**ANGELO'S RECYCLED MATERIALS
PROPOSED CLASS I FACILITY
PERMIT APPLICATION MODIFICATIONS
RESPONSE TO FDEP REQUEST FOR
ADDITIONAL INFORMATION**

Re: Angelo's Recycled Materials Proposed Class I Facility
Permit Application Modifications
FDEP Pending Permit Nos.: 22913-001-SC/01 and 32913-002-SO/01
Response to FDEP Request for Additional Information
Jones Edmunds Project No. 95380-436-09

This letter has been prepared in response to the request for additional information (RAI) prepared by the Florida Department of Environmental Protection (Southwest District Office), dated September 4, 2009. Each of the Department's comments is presented below in *italics*, followed by the response in **bold** type.

FIGURE 15A
WELL LOCATION MAP
ENTERPRISE RECYCLING
AND DISPOSAL FACILITY
PASCO COUNTY, FLORIDA

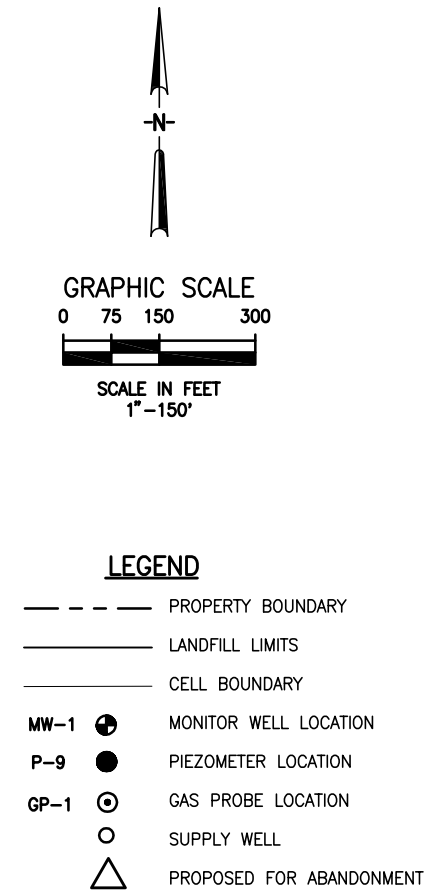
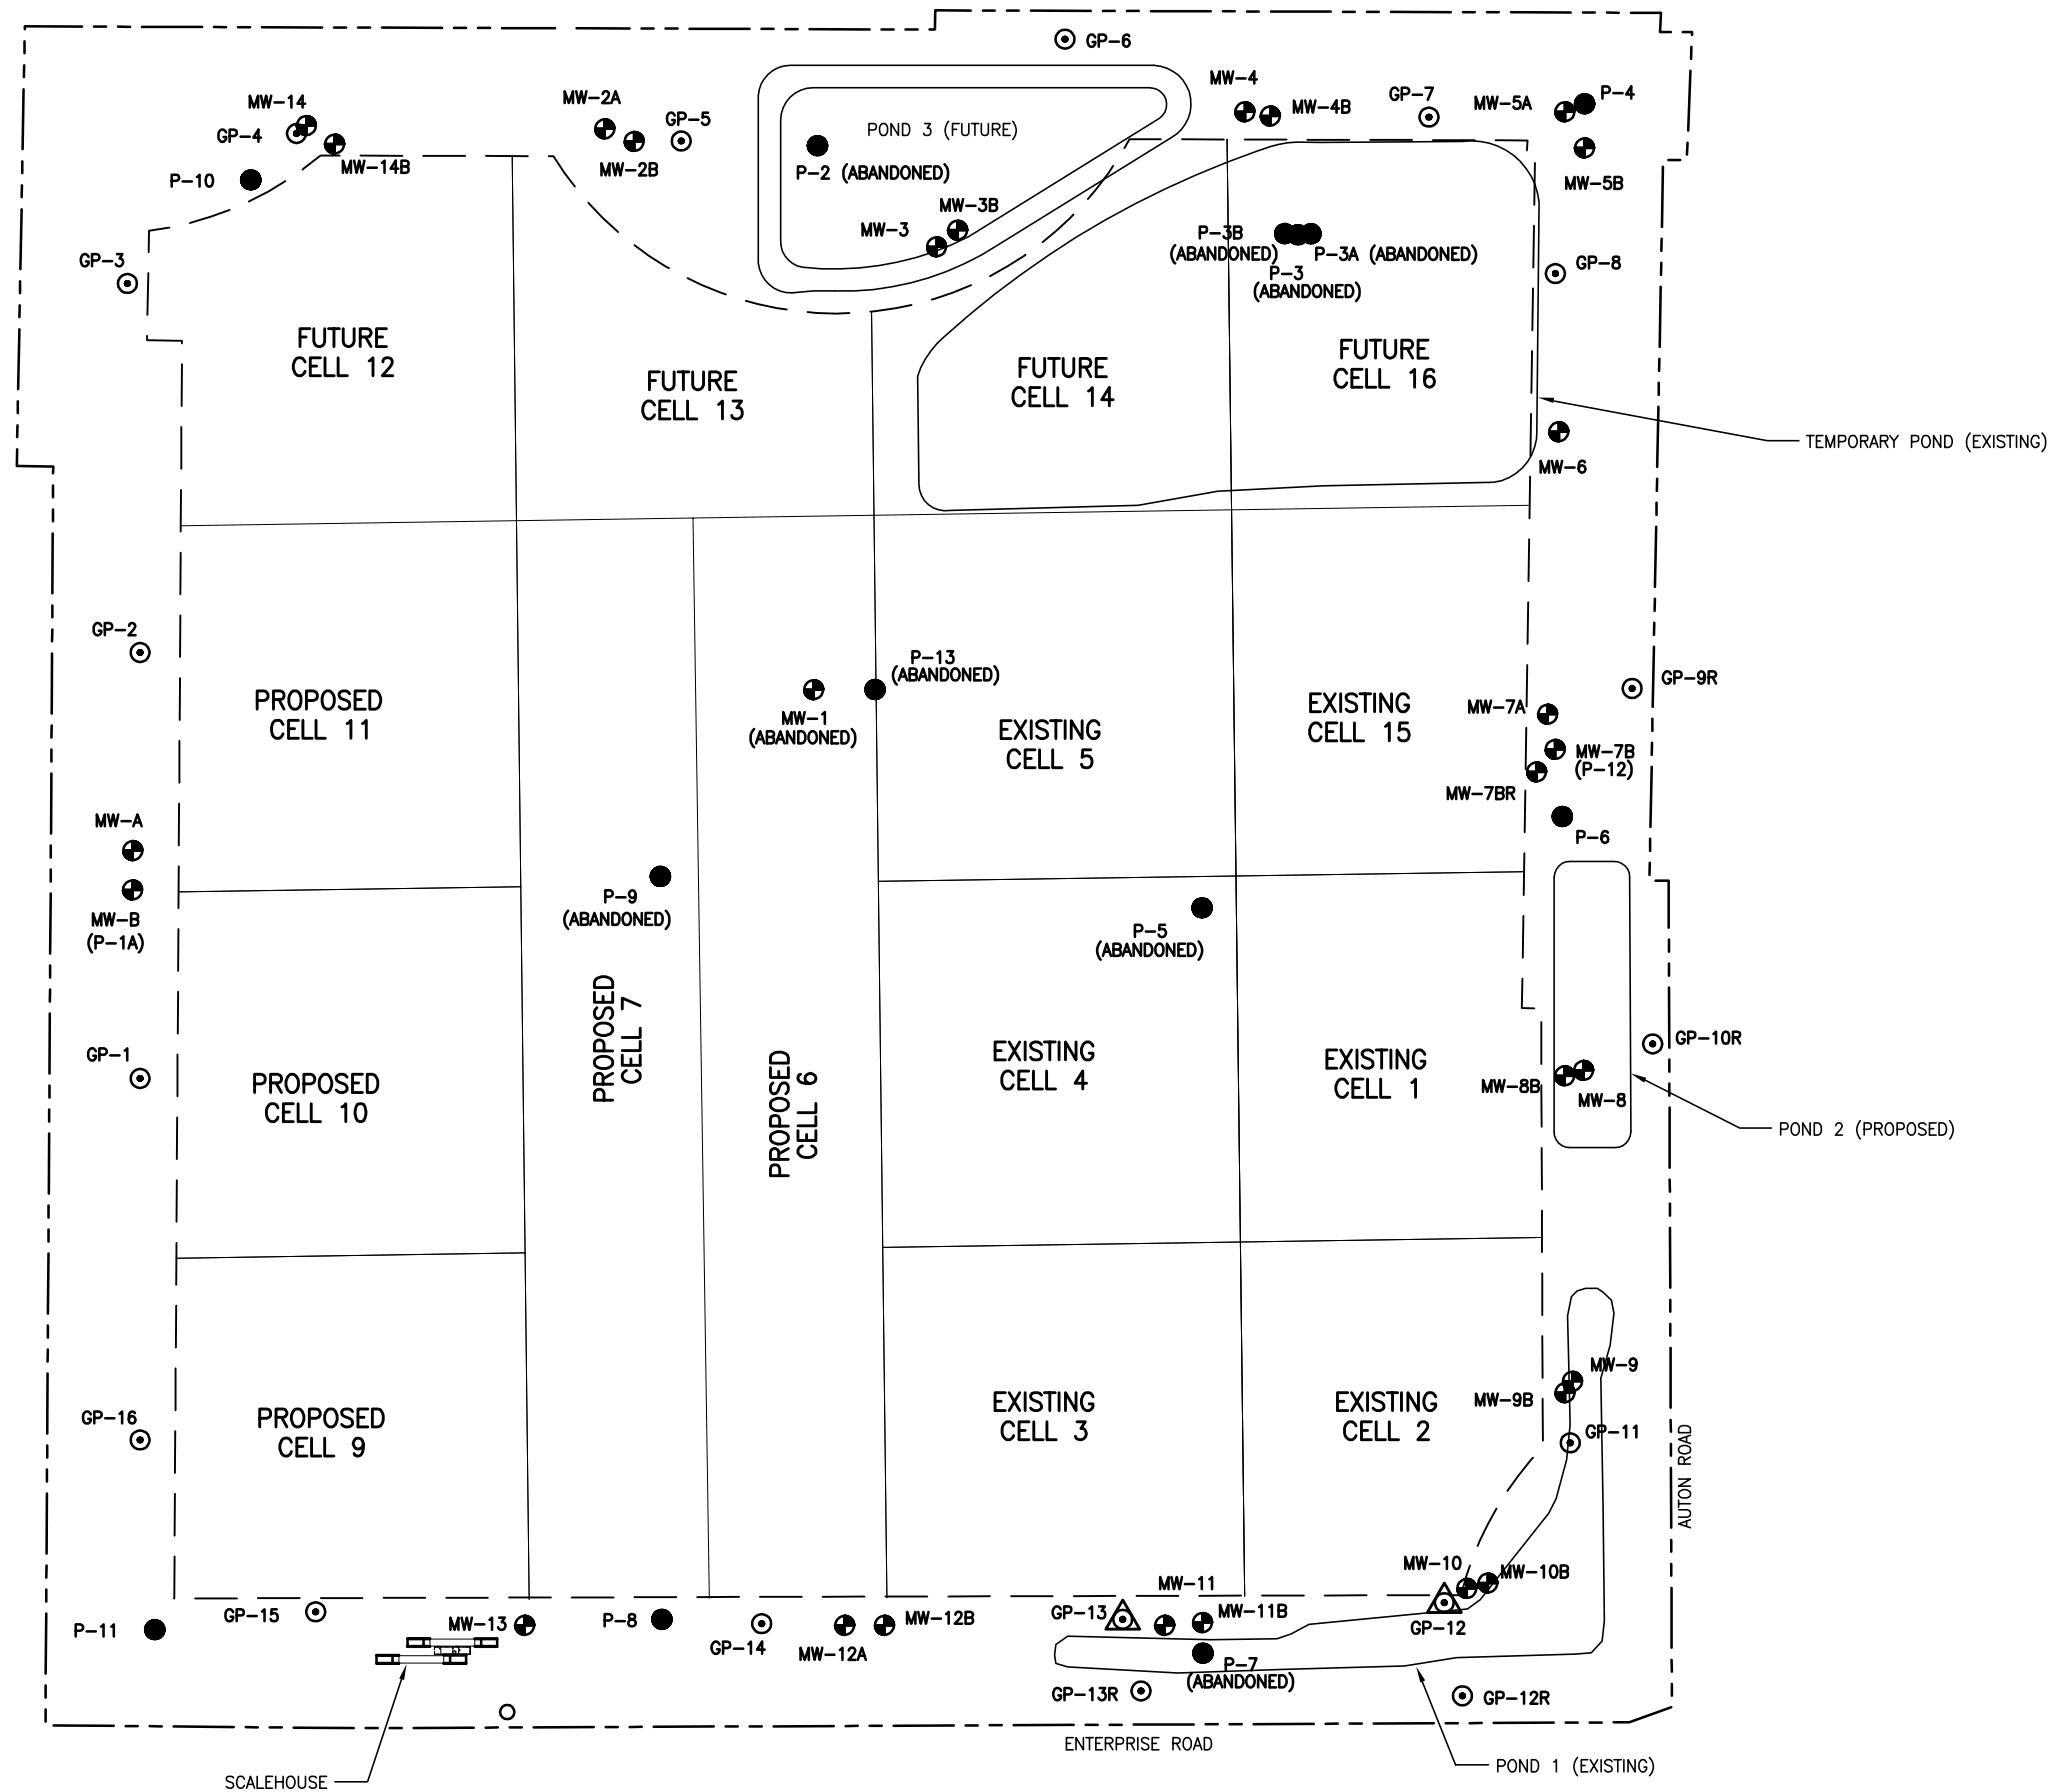
Comment 3: Rule 62-701.510, F.A.C. Enterprise Class III Landfill Permit Renewal, Pasco County Hydrological Investigation and Groundwater Monitoring Plan, prepared by Jones Edmunds, dated November 2006: It appears that the sequence of monitoring well installation and the phased incorporation of monitor wells into the groundwater monitoring plan (GWMP) for the facility will need to be revised based on the revised sequence of cell construction and operation. Please revise the narrative in Section 5.3.1 of the above report and any applicable figures in the above report to be consistent with the revised sequence of construction and operation, accordingly, to depict the revised cell and sequence numbers. Please contact John Morris at (813) 632-7600 ext 3336 to discuss your proposed changes to the GWMP, prior to response to this comment.

Comment 4: Rule 62-701.510, F.A.C. Figure-01 "Proposed Site Monitoring Network September 2007", prepared by HDR Engineering, received September 27, 2007: Please revise this figure (in a black-and-white format, no larger than 11x17 inches for use as a permit attachment) to show the revised cell configurations and numbering, locations/identification numbers of existing and proposed monitor wells/piezometers, and revised locations/identification numbers of gas monitoring probes at the facility.

Response 3: The sequence of monitoring well installation and the phased incorporation of monitoring wells into the GWMP for the facility have been revised based on the revised sequence of cell construction and operation. Figure 15A and the phasing schedule listed on page 5-18 of the November 2006 GWMP have been revised as requested and are included as Attachment 3. Mr. John Morris was contacted on October 2, 2009 to discuss the proposed changes to the GWMP.

Response 4: The referenced HDR figure has been replaced with the Jones Edmunds Figure 15A, Well Location Map (See Response 3). The figure shows the revised cell configurations and numbering, locations/identification numbers of existing and proposed monitoring wells/piezometers, and revised locations/identification numbers of gas monitoring probes at the facility. Please see the revised figure submitted as Attachment 3.

FIGURE 3-13
GAS MONITORING PROBE LOCATION MAP
ENTERPRISE RECYCLING
AND DISPOSAL FACILITY
PASCO COUNTY, FLORIDA

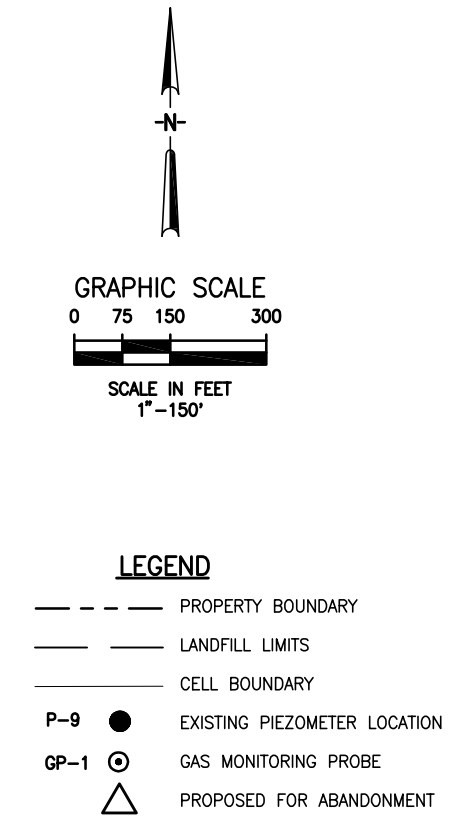
- a. Please revise Section 3.10 of the Engineering Report, where applicable, to include the proposed additional gas monitoring probe in the facility's gas monitoring plan and on applicable figures (e.g. Figures 3-13 and 3-15).*

Response 5.a: Figures 3-13 and 3-15 have been revised to include the recently installed gas monitoring probes GP-12R and GP-13R. Since these figures were originally generated by HAI, Jones Edmunds re-created these figures and made the appropriate updates. Please see the revised figures contained in Attachment 5.a.1. Please also note that the gas probes have been included in the new Figure 15A (Attachment 3).

REVISED DRAWING C-5

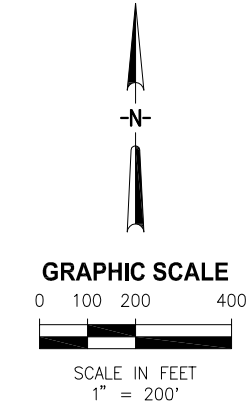
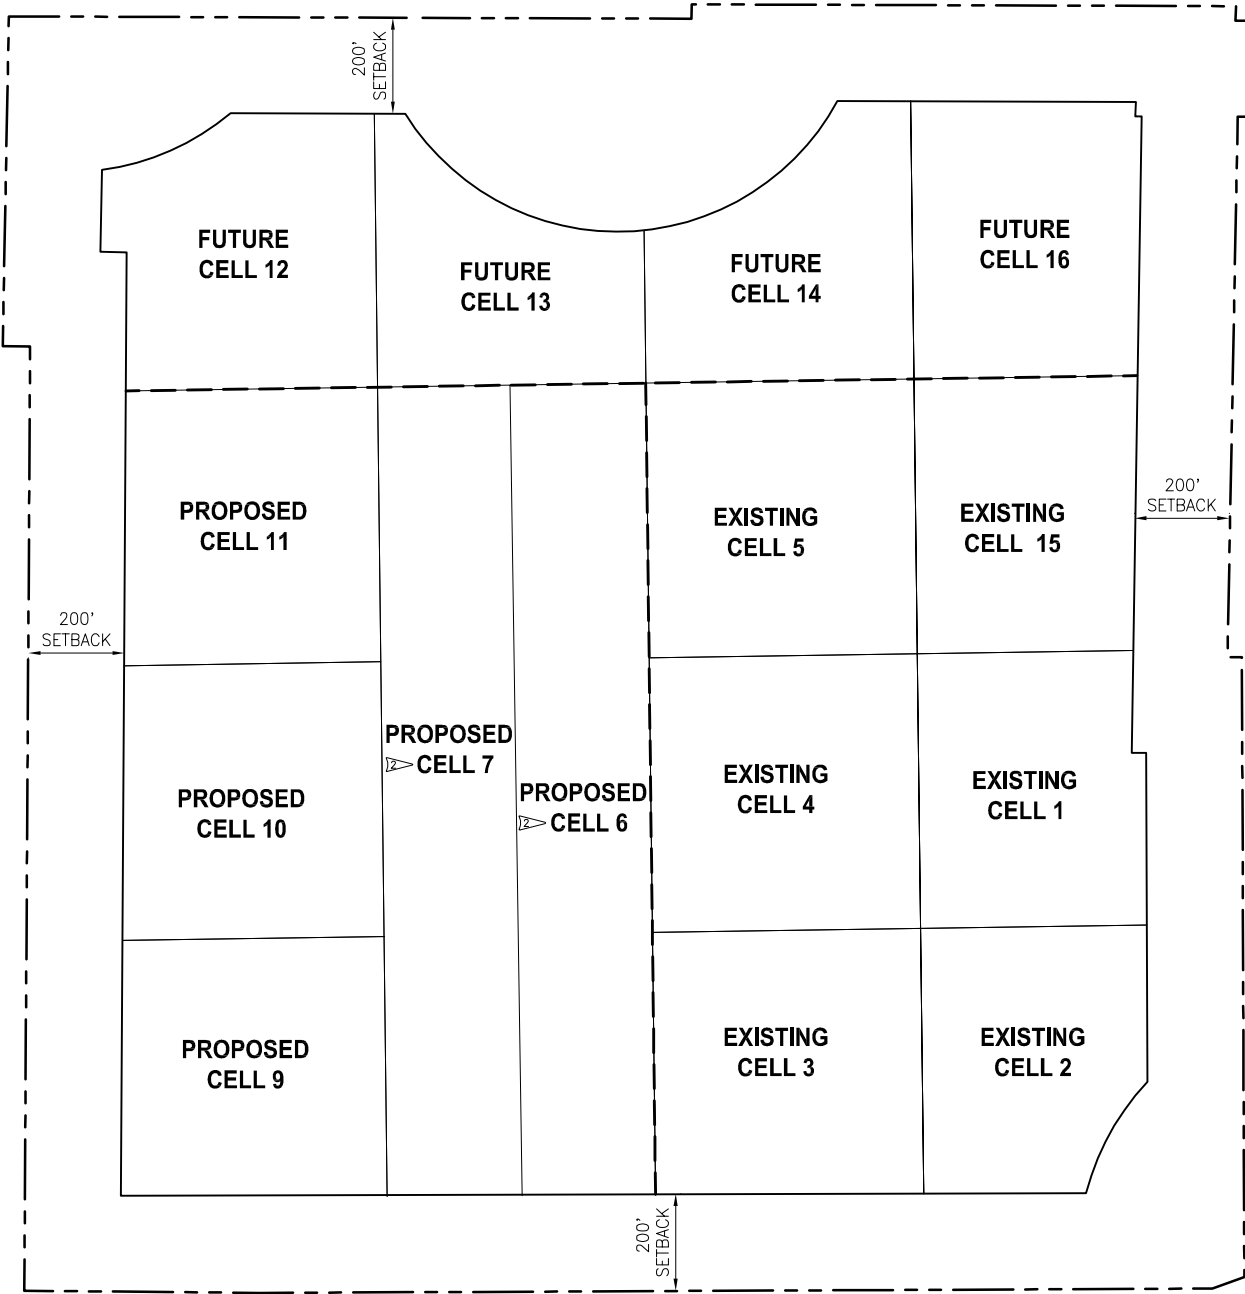
- a. *Sheet C-5: The revised sequence of fill narrative in Section 3.8 of the Operation Plan indicates that Cells 6 and 7 will also be filled during Fill Sequence 8. Please verify and revise the Excavation, Construction and Filling Sequence table on this sheet, as appropriate.*

Response 7.a: The Excavation, Construction and Filling Sequence table on Sheet C-5 has been revised to match the sequence of fill narrative in Section 3.8 of the Operation Plan. Please see the revised drawing included in Attachment 7.
